## Public Input No. 2480-NFPA 70-2023 [ Global Input ]

### Article 420 Ceiling Mounted Multi-Function Platforms

**Figure 406.3(F) Controlled Receptacle Marking Symbol:**

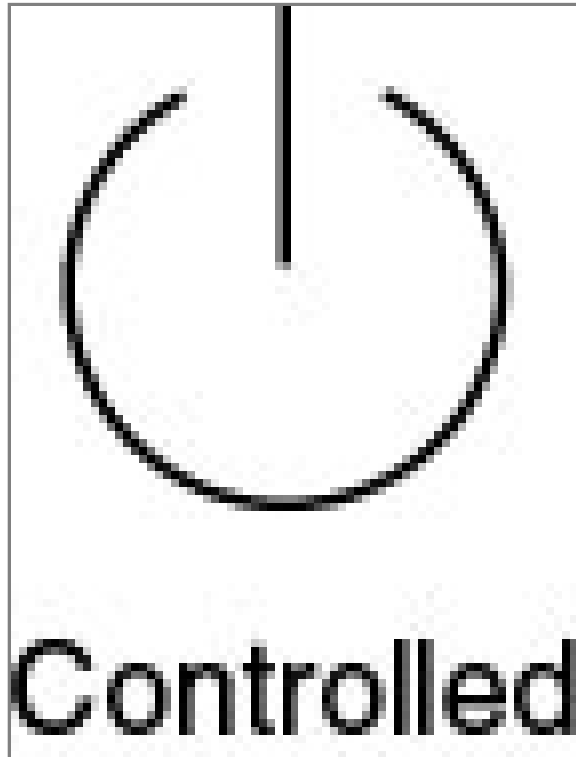
**Commented [TBL22]:** Figure 406.3(F) renumbered to 406.11(D).

**Figure Informational Note Figure 406.10(B) One Example of a Symbol Used to Identify the Termination Point for an Equipment Grounding Conductor.**

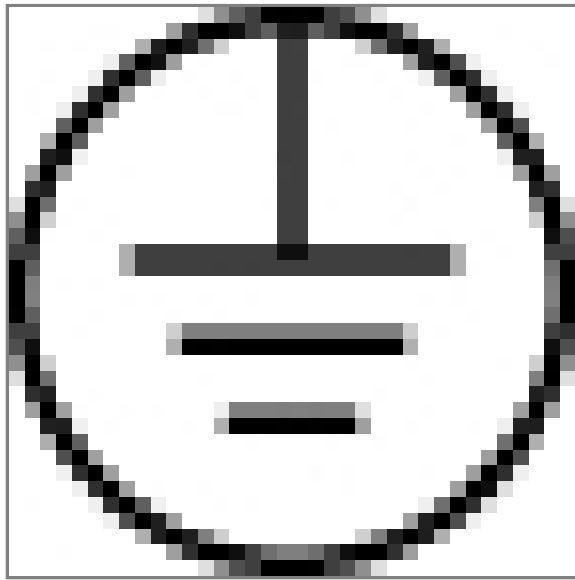
**Commented [TBL39]:** Reference to Figure 406.10(B) renumbered to Figure 406.22(B).

**Commented [TBL40]:** Figure 406.10(B) renumbered to Figure 406.22(B).

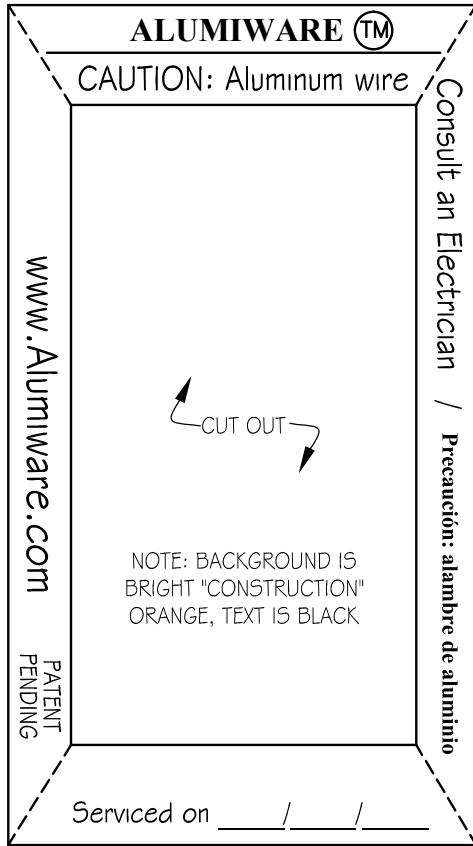
This input seeks to prevent mishandling of aluminum wiring conditions, when nonprofessionals seek to make repairs and/or receptacle changes without proper knowledge of aluminum wiring requirements. Many "do it yourself" homeowners, and amateur handymen will attempt to make repairs, when ignorant of aluminum wire conditions or hazards. This label will add an additional level of protection against incorrect material being used for repairs and modifications.

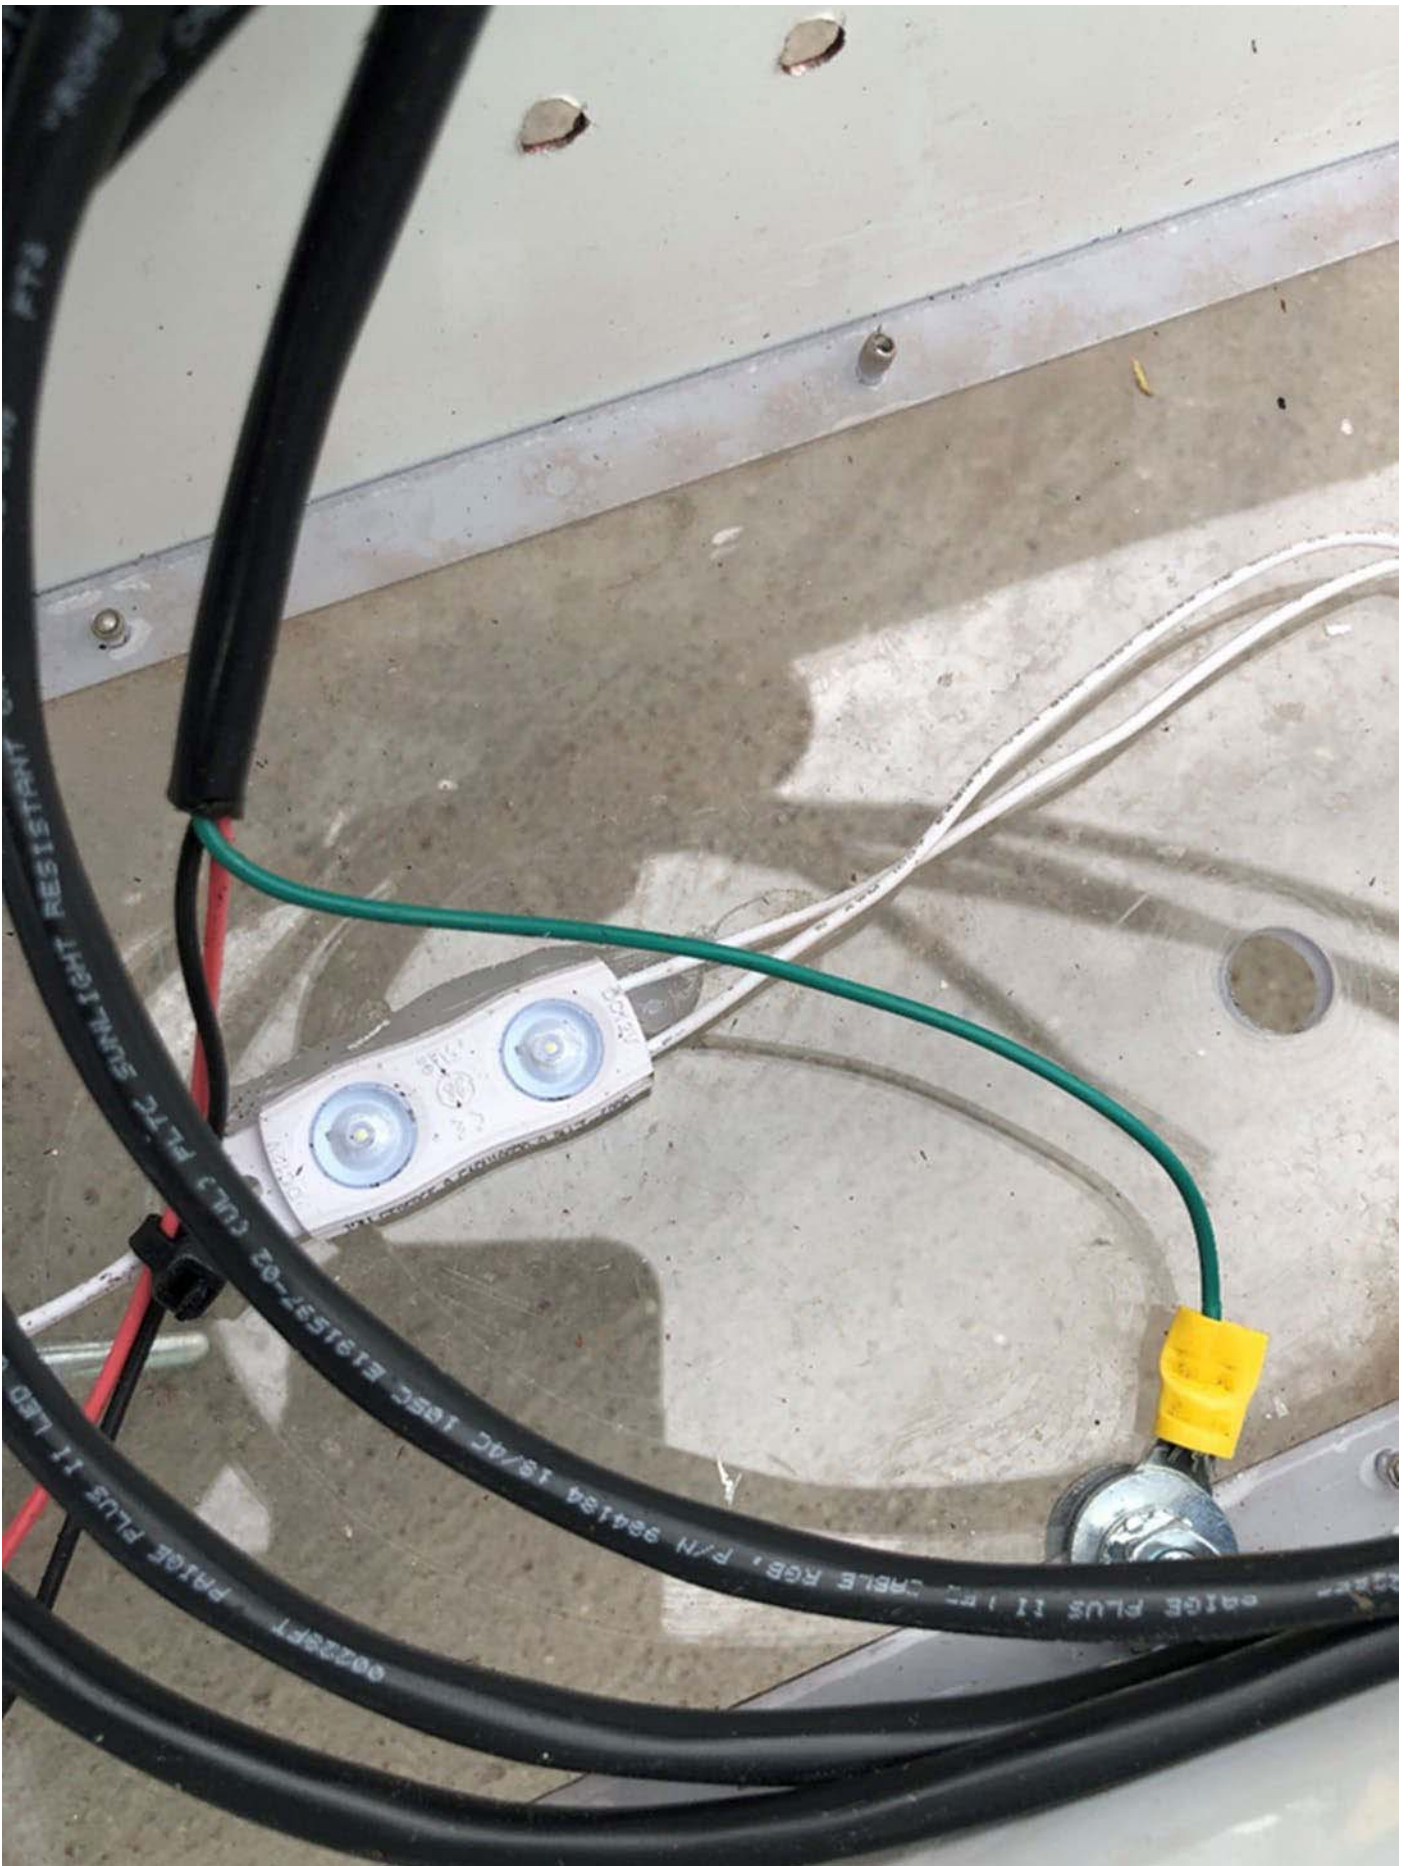
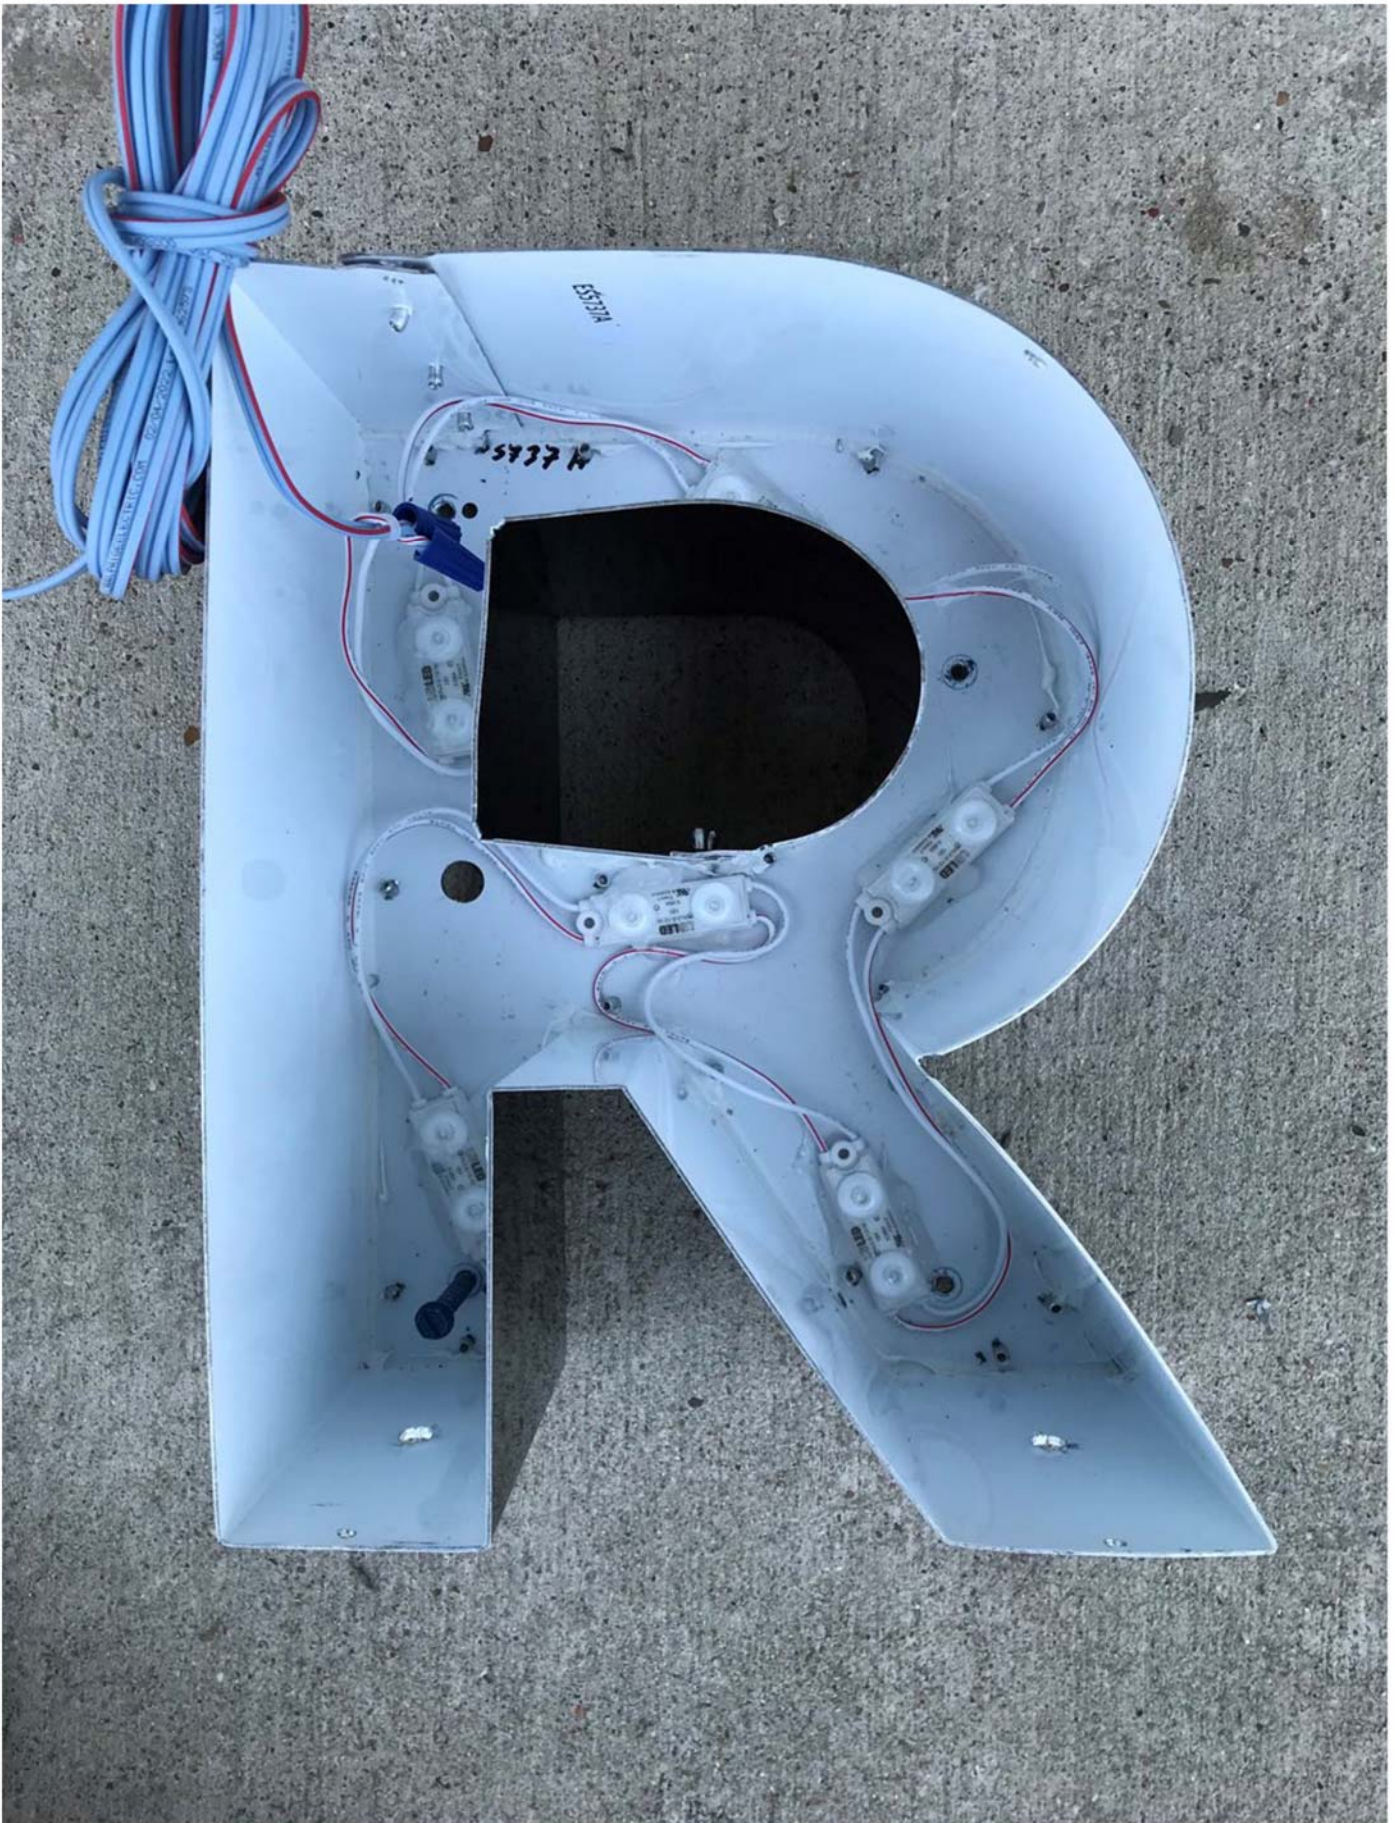
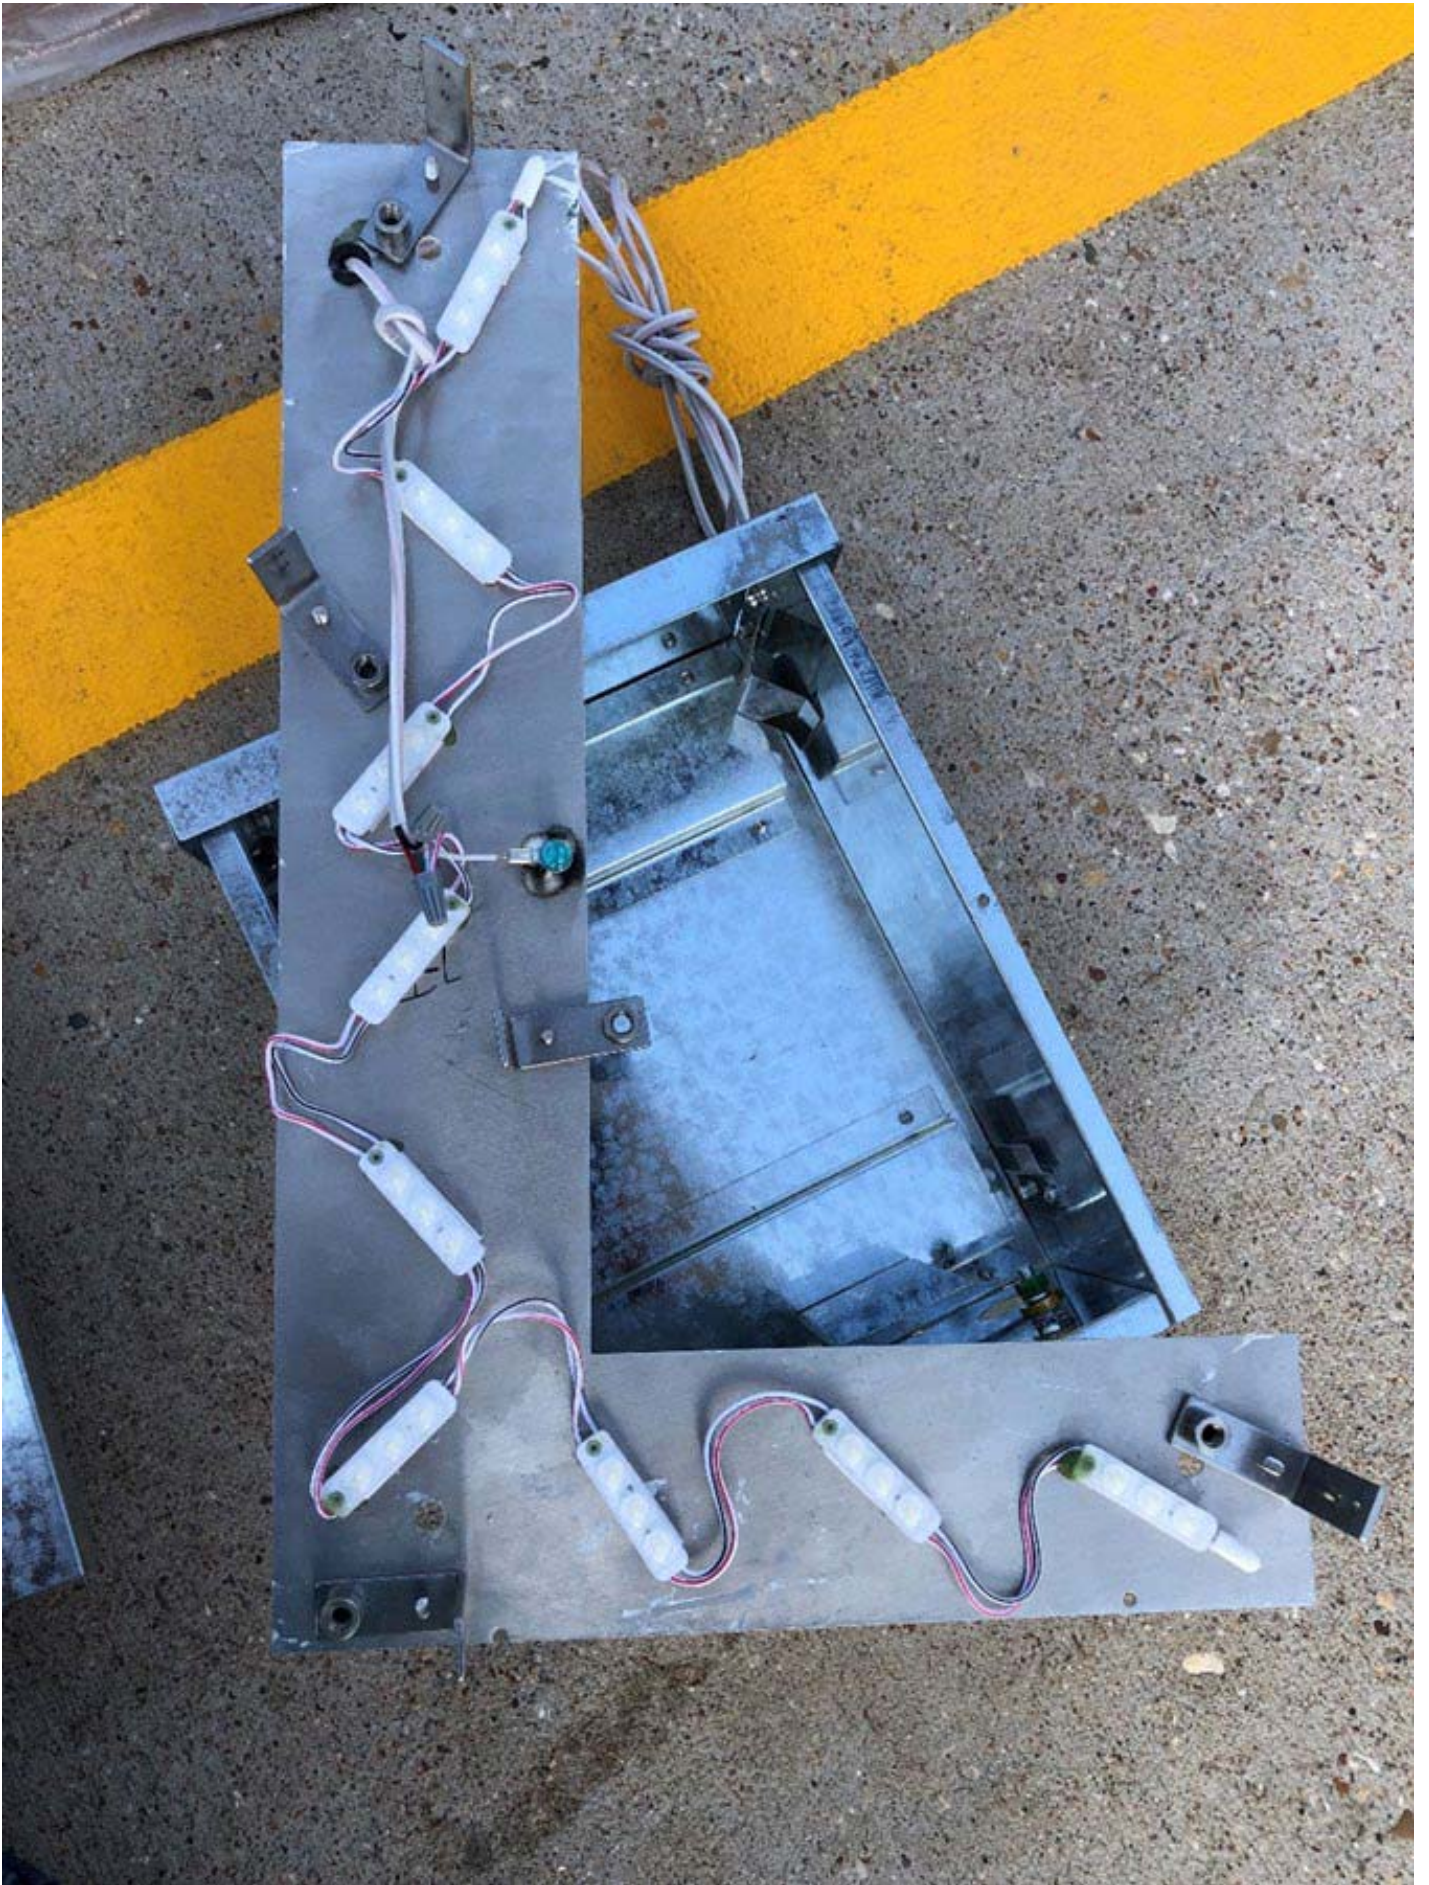
AHJ's, designers, and installers are not familiar with this Code section and do not realize there are two distinct requirements. As an AHJ, we are consistently finding at a rough inspection that the metal of remote wired class 2 signs do not comply. They are fabricated and installed with a two-wire class 2 cable and the metal parts are not bonded together as required because the text does not indicate that it applies to all signs fabricated from metal parts regardless of the illumination type installed. The exception only describes that the bonding conductor does not have to be connected to the Equipment Grounding Conductor of the branch circuit for a remote wired class 2 sign. The exception is erroneously being applied resulting in a failure to comply with the Code.

Halo rear illumination with Plexi glass illuminated face. Metal not bonded. 2 wire Class 2 cable installed.

Halo rear illumination with Plexi glass illuminated face. Metal bonded. 3 wire Class 2 cable installed.

Remote wired Class 2 channel letter metal not bonded. 2 wire Class 2 cable installed.

Remote wired Class 2 channel letter metal bonded. 3 wire Class 2 cable installed.

**Resolution:** The public input contradicts the intention of the Code, which does not require remote metal parts of a section sign or outline lighting system only supplied by a remote Class 2 power supply to be connected together or connected to the equipment grounding conductor of the branch circuit.
